**TCEQ DOCKET NO. 2024-1115-EAQ
PROGRAM ID NO. 13001906**

**IN THE MATTER OF THE
APPROVAL OF A WATER
POLLUTION ABATEMENT PLAN
BY VULCAN CONSTRUCTION
MATERIALS, LLC**

**PRESERVE OUR HILL COUNTRY ENVIRONMENT AND PRESERVE OUR
HILL COUNTRY ENVIRONMENT FOUNDATION'S
MOTION TO OVERTURN EXECUTIVE DIRECTOR'S DECISION**

Figure 6, Water Elevation in Wells Near Vulcan³³

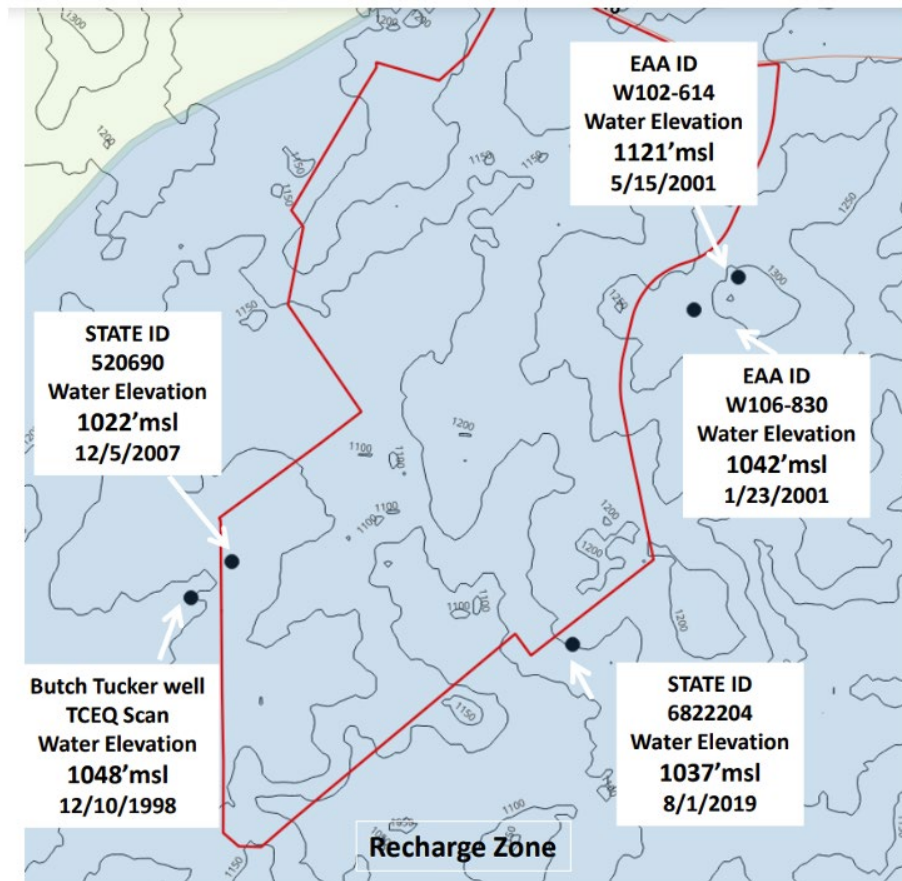
requisite WPAP.³² This monitoring plan is also inconsistent with TCEQ's BMPs. Thus, the authorized excavation depth, and the monitoring plan used to justify that depth, fail to meet the requirements of 30 Tex. Admin. Code §§ 213.5(b)(4)(B)(i), (ii), and (iii).

In fact, available water level data from several wells within 600 ft of the Vulcan property boundary shows water levels greater than 1022 ft-msl. *See* Figures 6 and 7 below.

Figure 7, Schematic Cross Section with Estimated Topography after Mining and Water Levels based on Available Data³⁴

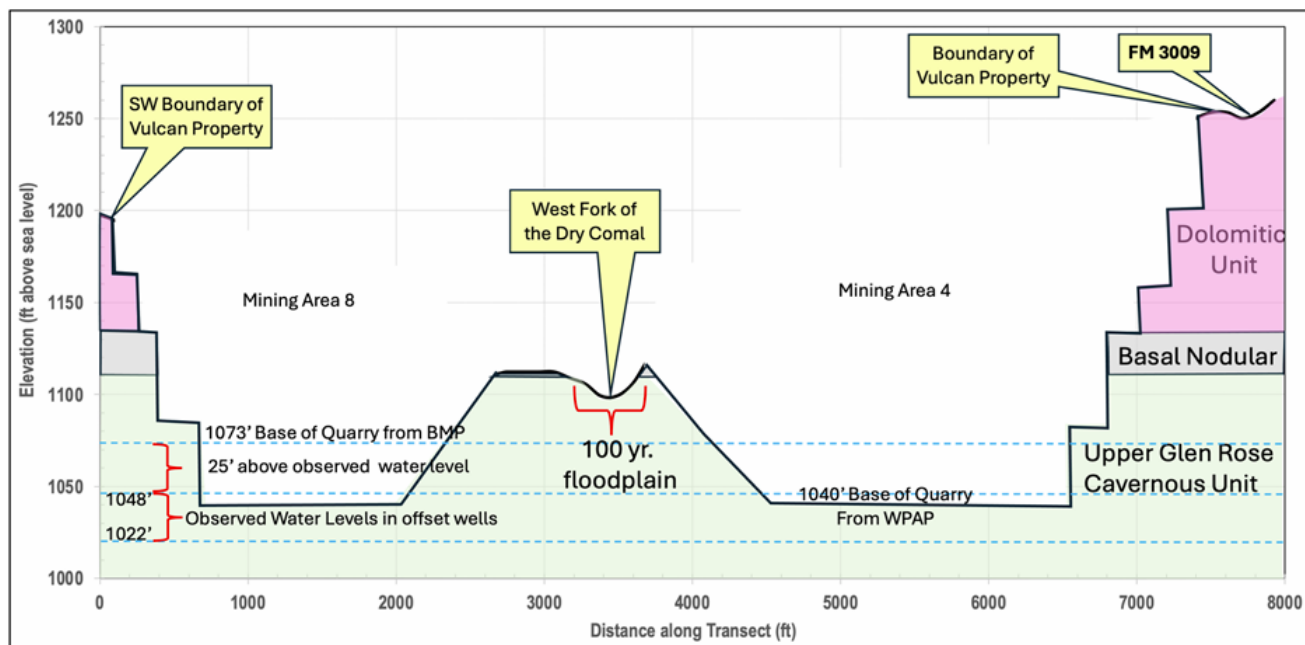
The WPAP does not provide any explanation or factual reference for a quarry floor base elevation of 1047 ft-msl but simply indicates that because it will take 5 to 10 years for the mining activities to reach that level, its proposal is to monitor the local water levels at the local wells and determine how those water levels correlate to established monitored water levels offsite. As Dr. Smith found, this monitoring plan is not, from a hydrology perspective, an adequate substitute for evaluating water levels *before* obtaining the

Figure 9. Schematic cross section with estimated topography after mining and water levels based on available data (J. Finneran, personal communication, April 16, 2024).

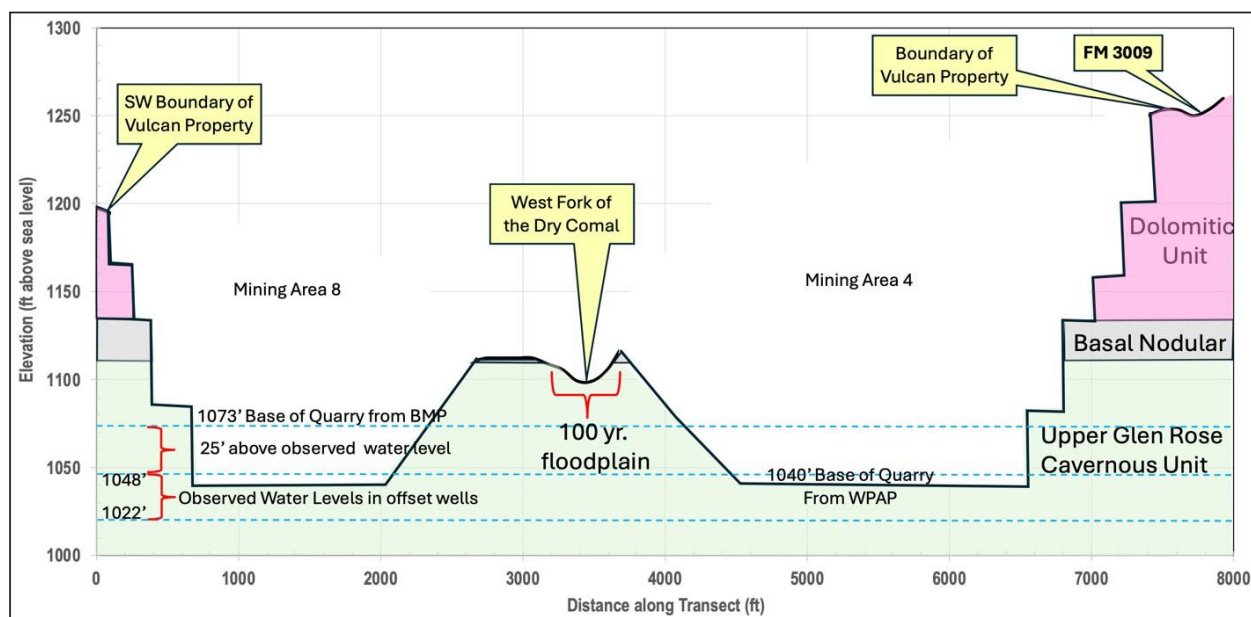
The WPAP (Pape-Dawson Engineers, 2024) for the site states that the mining areas will not be mined below an elevation of 1040 ft msl. According to the WPAP, this level of the quarry bottom will provide a 25-ft buder above the high water level of the aquifer. A review of available water-level data indicates that at times, the bottom of the quarry will be flooded by the underlying aquifer (Figure 9). Water-level data from five wells close to the perimeter of the quarry boundary were evaluated to estimate expected water levels beneath the quarry and proposed depths of the excavations (Appendix B) (J. Finneran, personal communication, April 16, 2024). The White #4 well (#520690) had a water level of 1022 ft-msl on 12/5/07. At this water level plus the 25-ft buder, the bottom of the quarry would be out of compliance. Another well (Tucker, EAA #Wxxx-137) had a water level of 1048 ft on 12/14/98. At this water level, the bottom of the quarry would be 8 ft below the water level in the aquifer.

Figure 9. Schematic cross section with estimated topography after mining and water levels based on available data (J. Finneran, personal communication, April 16, 2024).

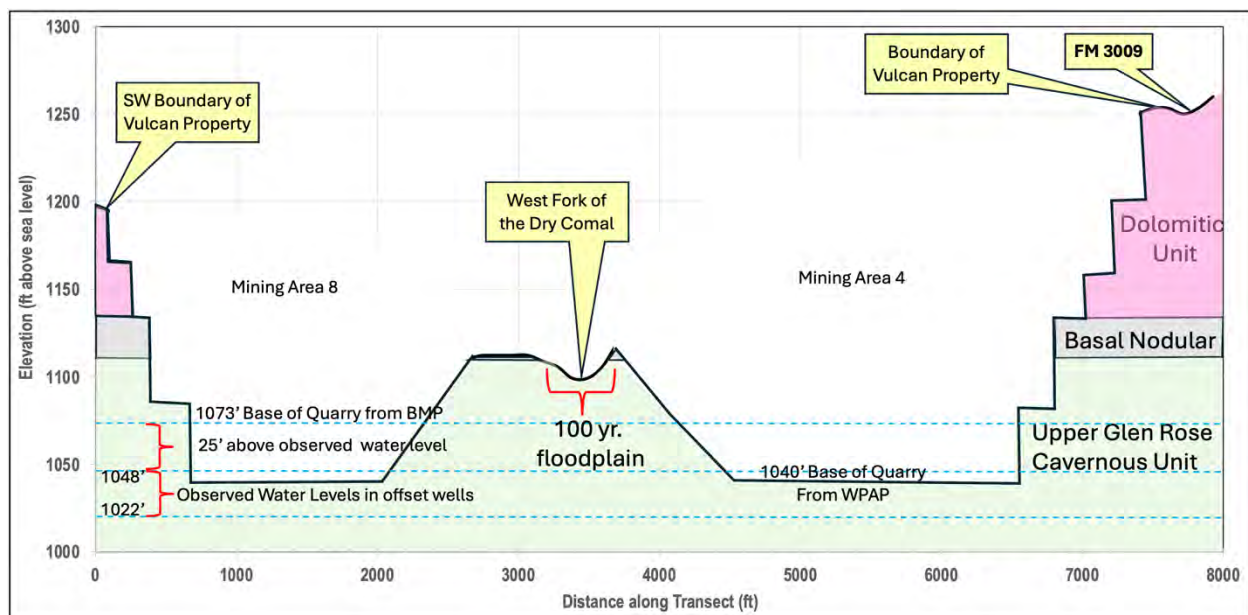
The WPAP (Pape-Dawson Engineers, 2024) for the site states that the mining areas will not be mined below an elevation of 1040 ft msl. According to the WPAP, this level of the quarry bottom will provide a 25-ft buffer above the high water level of the aquifer. A review of available water-level data indicates that at times, the bottom of the quarry will be flooded by the underlying aquifer (Figure 9). Water-level data from five wells close to the perimeter of the quarry boundary were evaluated to estimate expected water levels beneath the quarry and proposed depths of the excavations (Appendix B) (J. Finneran, personal communication, April 16, 2024). The White #4 well (#520690) had a water level of 1022 ft-msl on 12/5/07. At this water level plus the 25-ft buffer, the bottom of the quarry would be out of compliance. Another well (Tucker, EAA #Wxxx-137) had a water level of 1048 ft on 12/14/98. At this water level, the bottom of the quarry would be 8 ft below the water level in the aquifer.

Figure 1

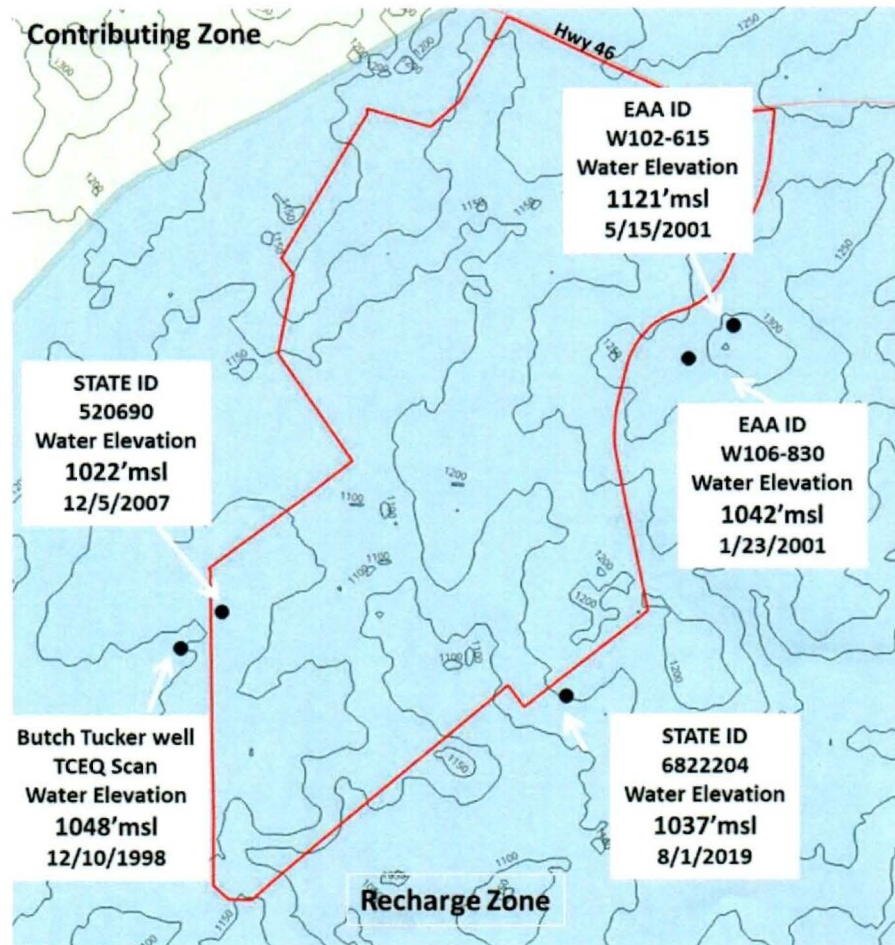
5. During my review of Vulcan's WPAP, I analyzed the separation distance between the floor of the quarry and groundwater. The amended Application states that the Mining Areas will not be mined below 1047 feet-msl. I found that water level data from the Texas Water Development Board from several wells within 600 feet of the Vulcan property boundary shows water levels greater than 1022 ft-msl. I prepared a map showing the location of those wells which is labeled as **Figure 1**, below:

Figure 3. Abundant caves indicate the sensitivity of the area, and along with the density of karst feature mapped directly across highway 46 contrasts with the density of features mapped in the Vulcan site assessment.

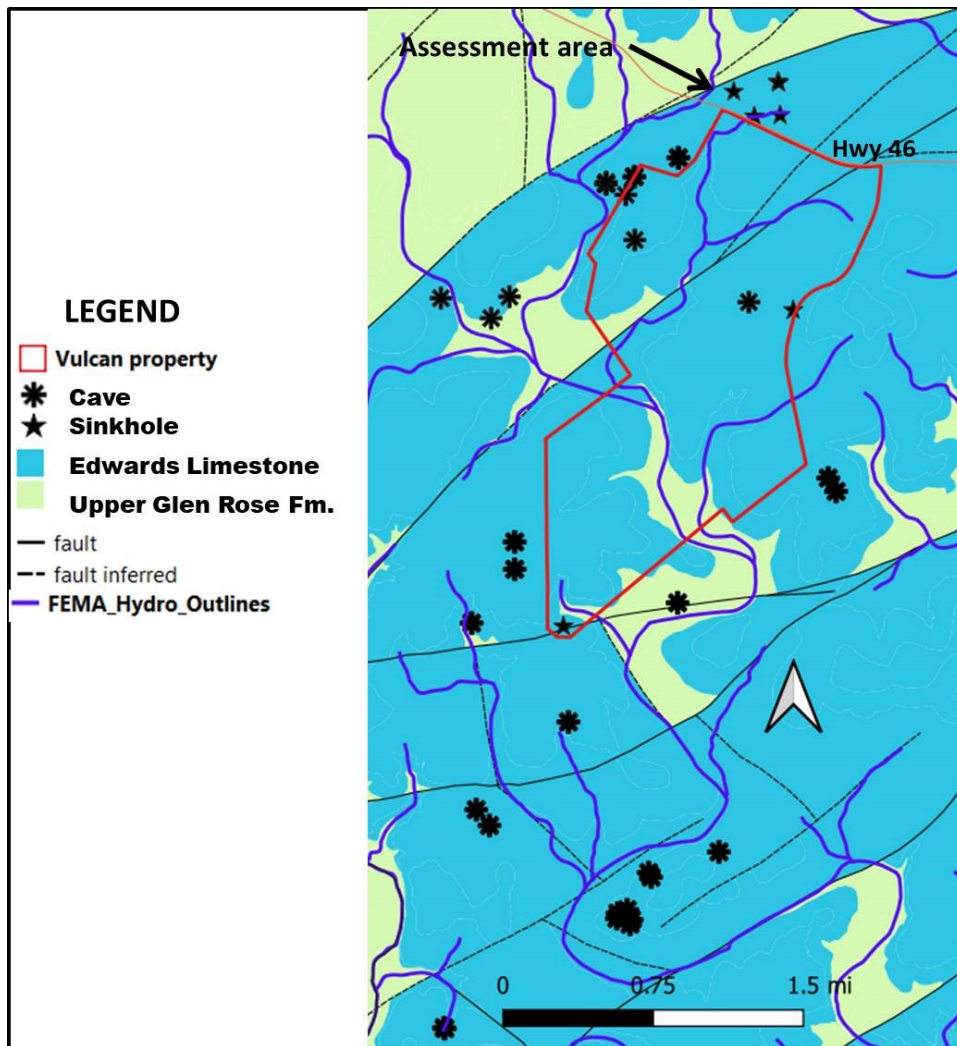
The site chosen for the Vulcan Comal Quarry is especially unsuitable for a quarry. Despite the claim in the WPAP that there is low potential for fluid migration into the aquifer, the abundance of caves in the vicinity show the area to be sensitive (Figure 3). Also, it should be noted that there is a subjective aspect to identifying sensitive features. The contrast in the density of features recorded at the Vulcan site and those recorded in a site assessment for a much smaller area directly on the other side of highway 46 suggests sensitive features on the Vulcan site may be undercounted.

Figure 4. One observed water elevation on the Vulcan property and four within a few hundred feet of the property demonstrate that the water levels in the area repeatedly reach elevations that would put Vulcan's desired elevation for the base of the quarry in violation of the TCEQ BMP.

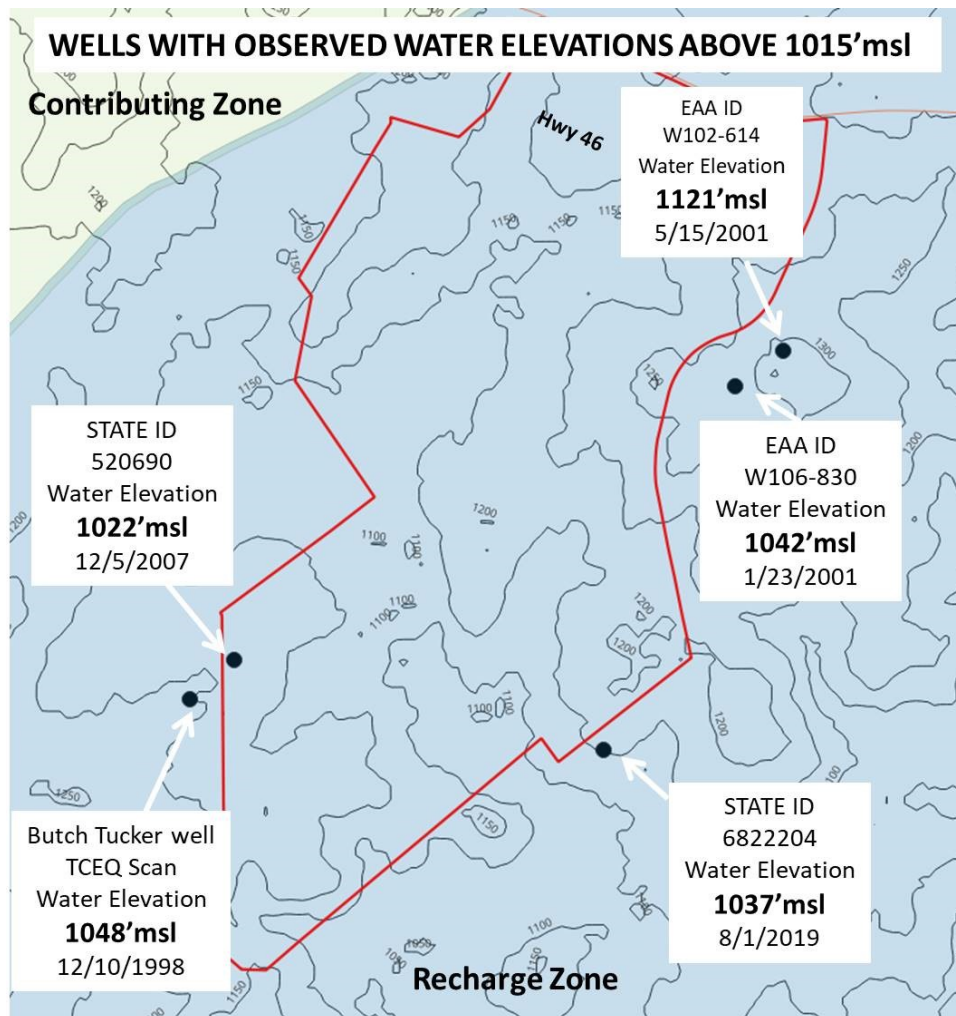
varying precipitation for the next 64-96 years. For the 1040' msl quarry base to be compliance with the TCEQ BMP, the highest elevation expected for the aquifer would have to be no higher than 1015' msl. In fact, five wells already drilled on or within several hundred feet of the property document different times over a 21 year span when a 1040' msl quarry base would have violated the TCEQ BMP (Figure 4). Three of those wells the recorded aquifer elevations above 1040' msl. Well monitoring would have value if its purpose is to monitor contaminant concentrations. Water level monitoring might allow mining activity to stop when level approaches 1015' msl, but if the 1040' msl level has already been reached in parts of the quarry, those areas will flood. The only thing that can be stated factually is that if Vulcan had been allowed to start this project in 1990 we would have already seen the quarry floor in excavated areas flood three times. Each time would bring the aquifer directly into contact with nitrate and other contaminants accumulated there. It is unlikely that the five wells drilled at random dates have actually identified the maximum possible elevation, and there is no reason to think the aquifer will not
